PRE-BID AMMEDMENTS/CLARRIFICATIONS

NAME OF THE WORK: DESIGN, CONSTRUCTION, ERECTION, TESTING AND COMMISSIONING OF 20 MLD TERTIARY TREATMENT PLANT FOR NTPC KORBA INCLUDING OPERATION AND MAINTENANCE OF ENTIRE SCHEME FOR 15 YEARS

System Tender No: 188173 NIT NO: 1507/WS/2026

Plot Plan

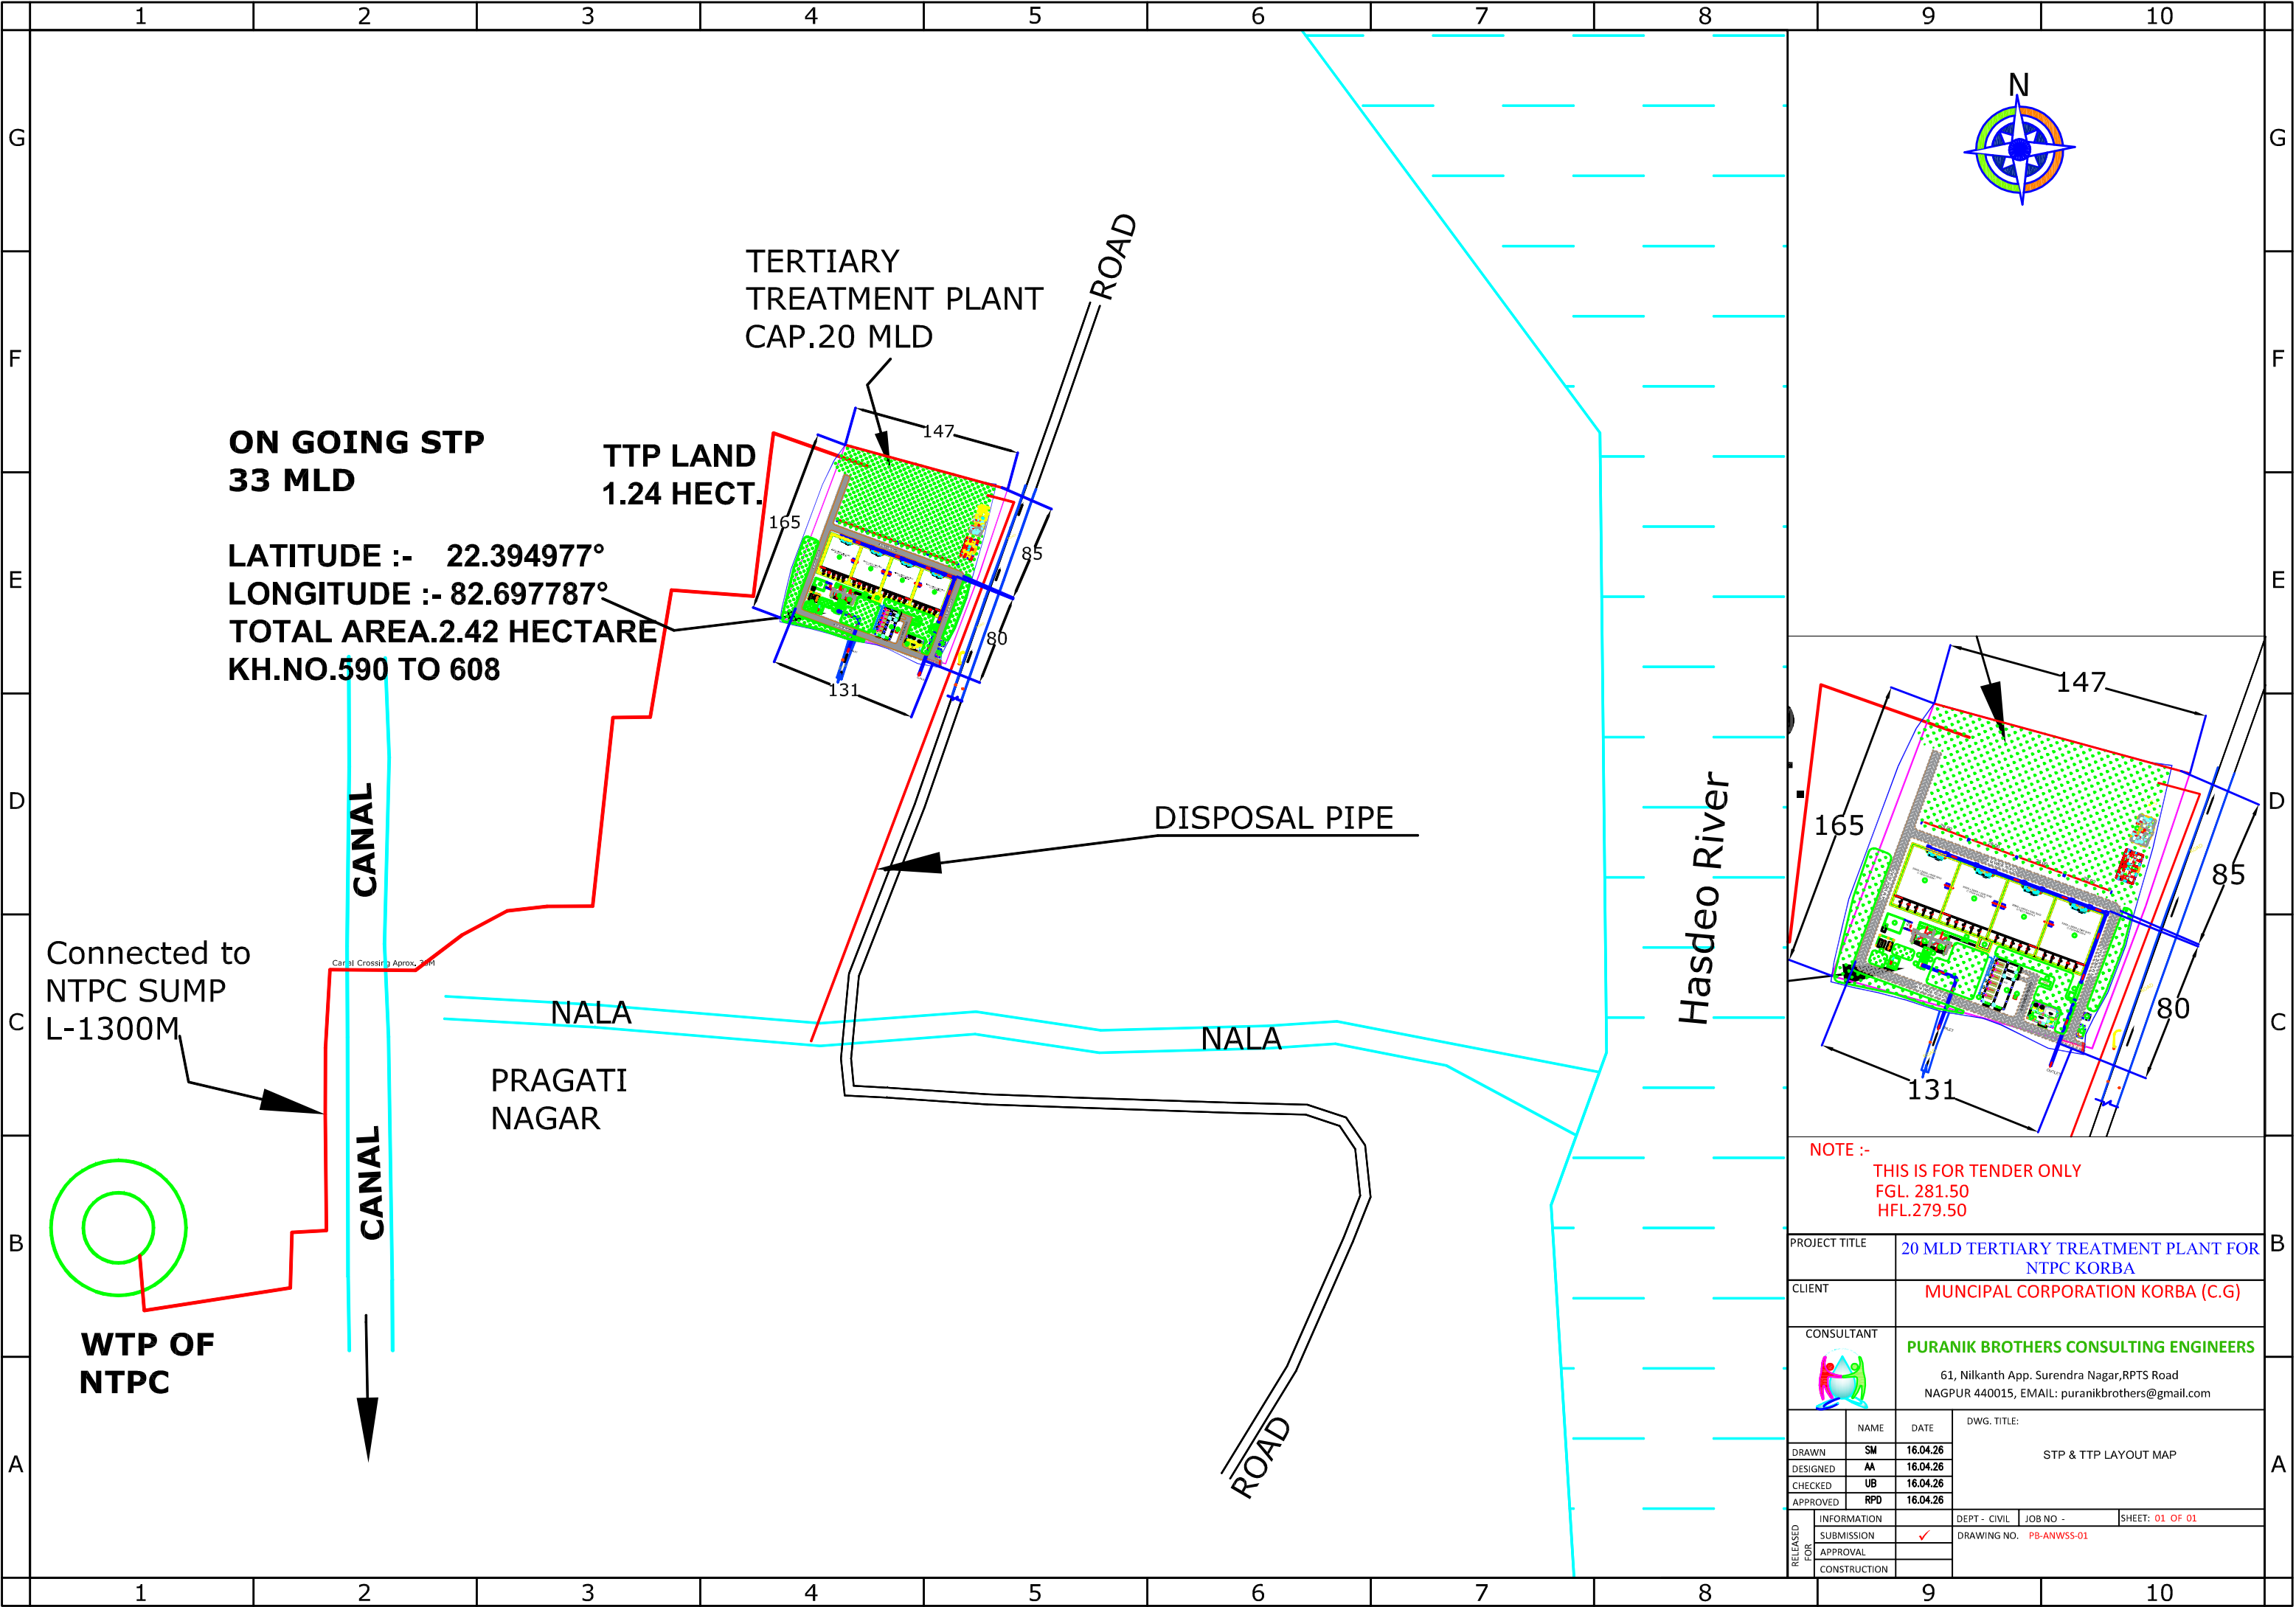
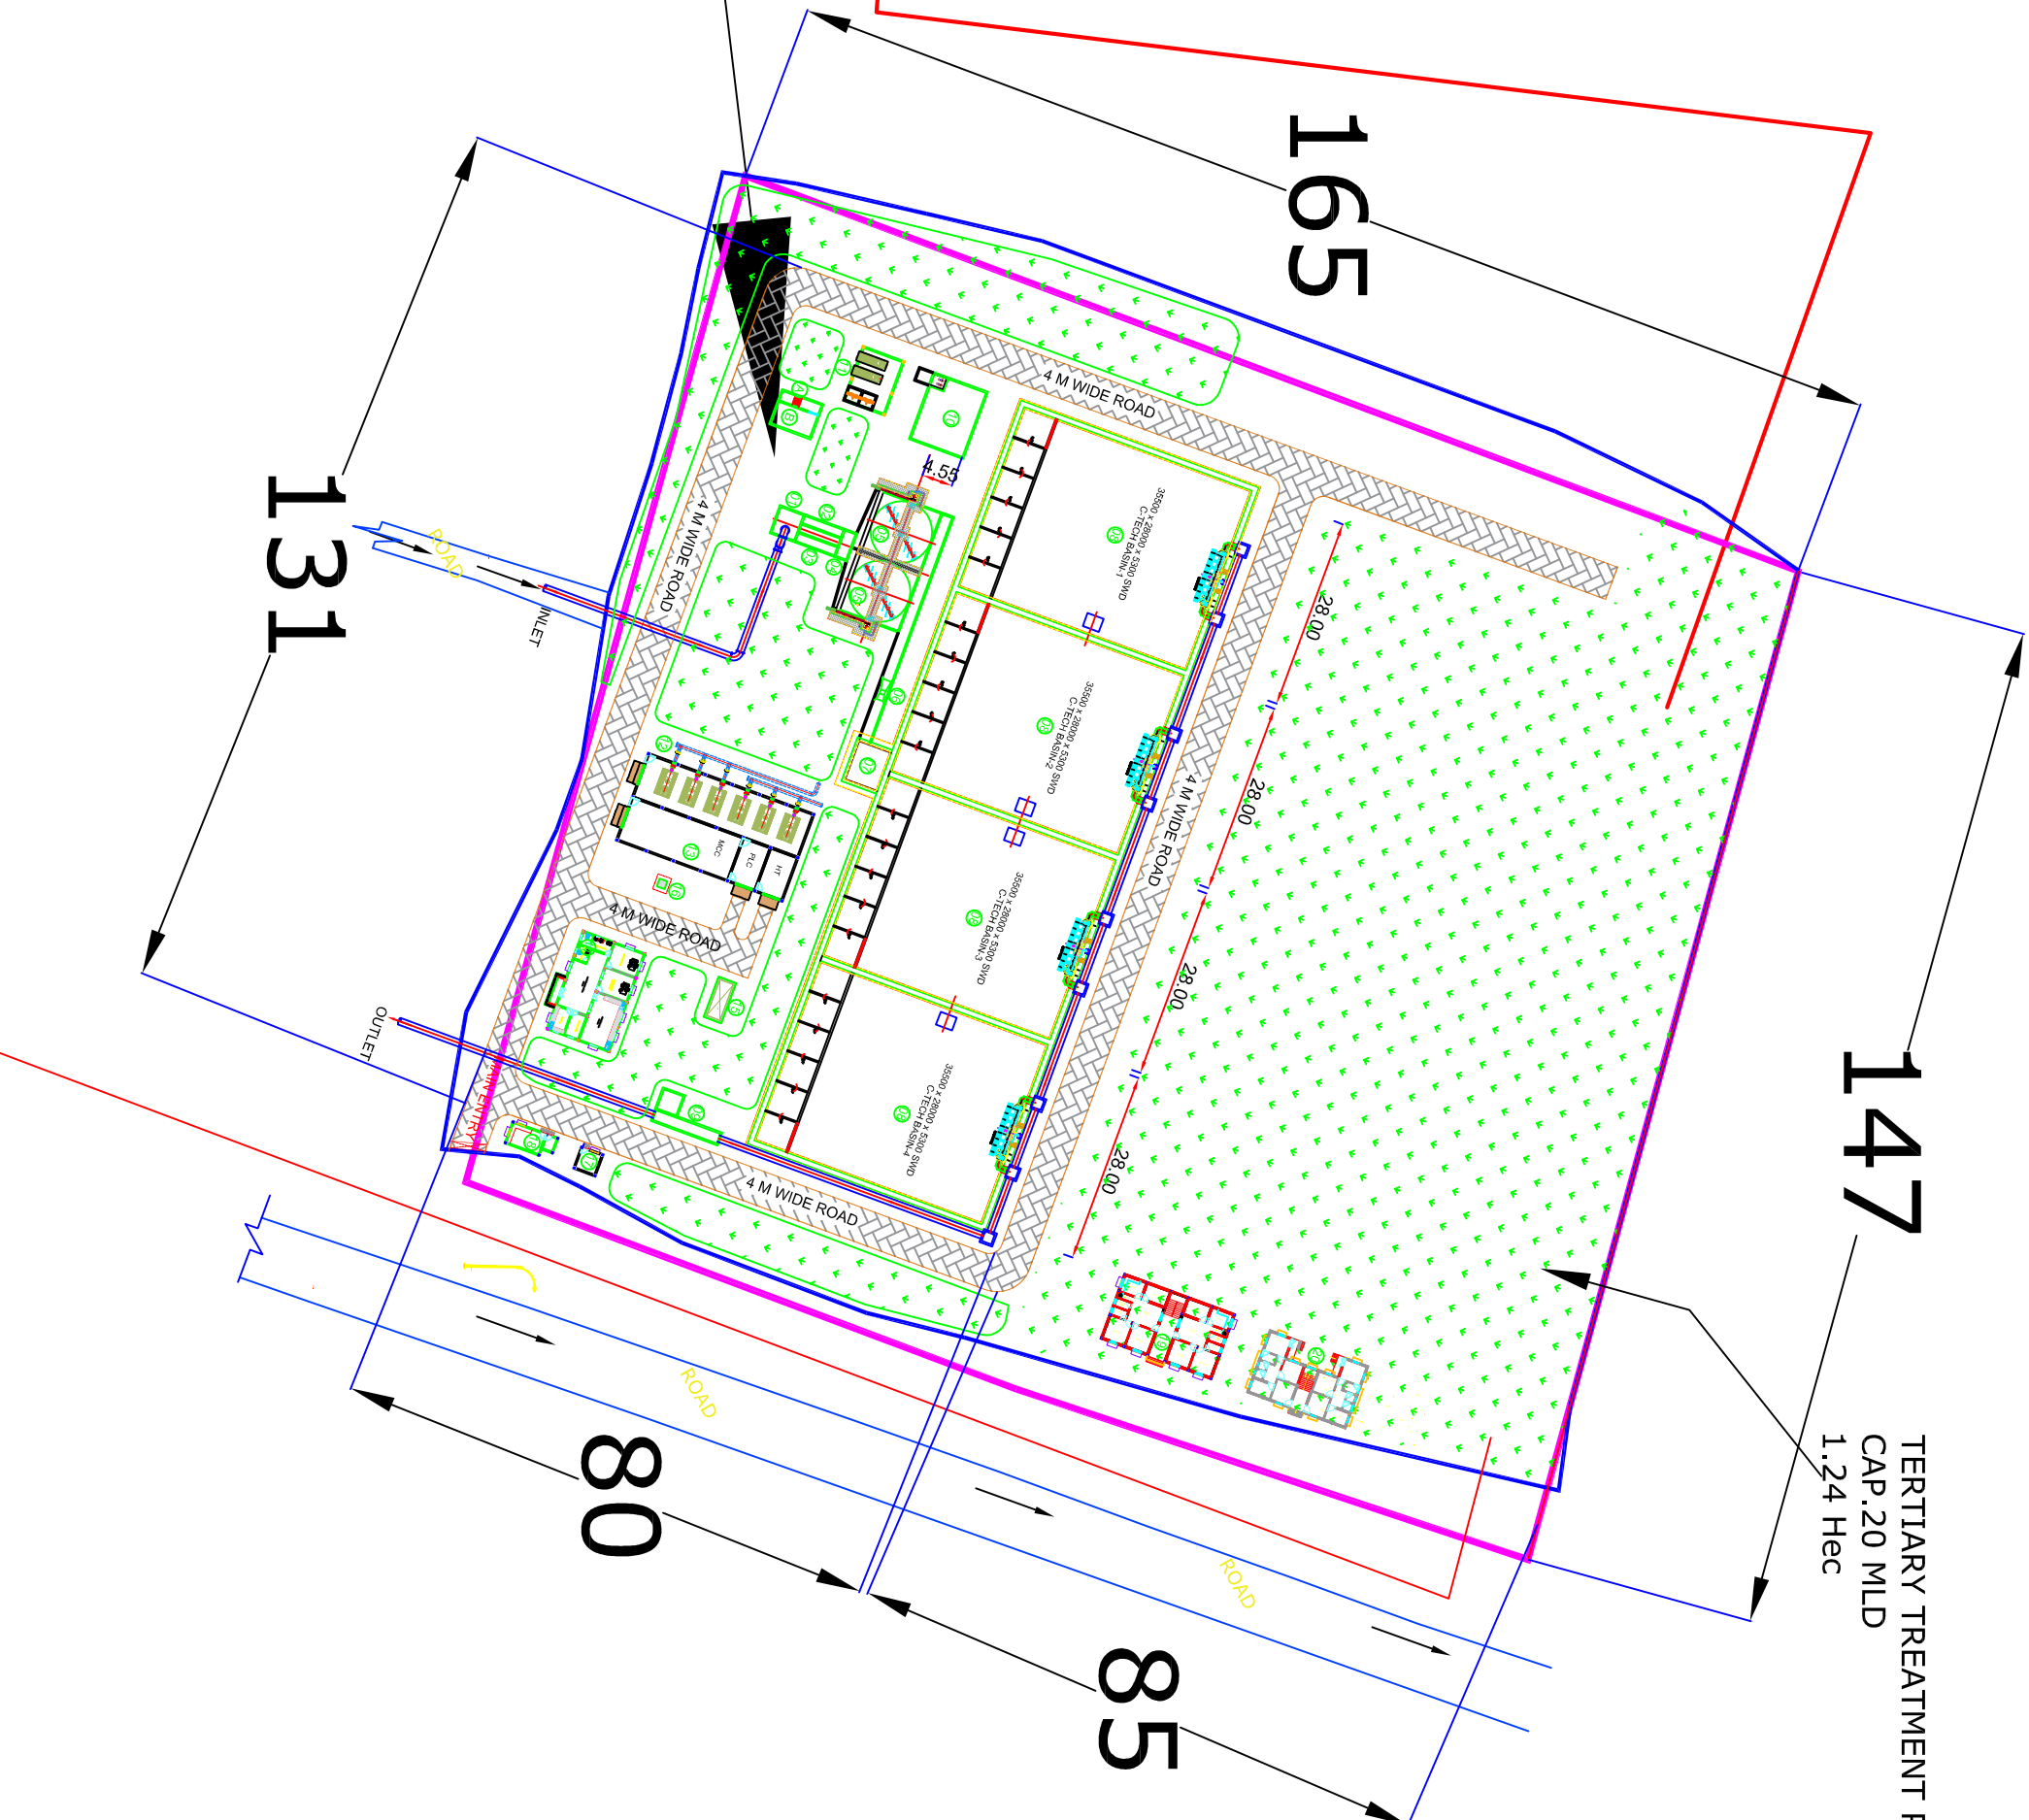
117.	General			Please provide the Plot Plan/layout details for Proposed 25 MLD TTP site.	Plot layout attached in Annexure. Kindly consider it only for reference purpose. Bidder need to ascertain and finalised the layout post detail survey.

189.			Plot Plan/ Layout Drawing	Kindly provide detailed plot plan / layout drawing, indicating plot boundaries, available area, levels, and location of existing/proposed units for proper system design and space planning.	Attached in Annexure. Shall be considered for reference purpose only. Bidder need to ascertain and finalize the layout post detail survey.

NOTE :-
THIS IS FOR TENDER ONLY
FGL. 281.50
HFL.279.50
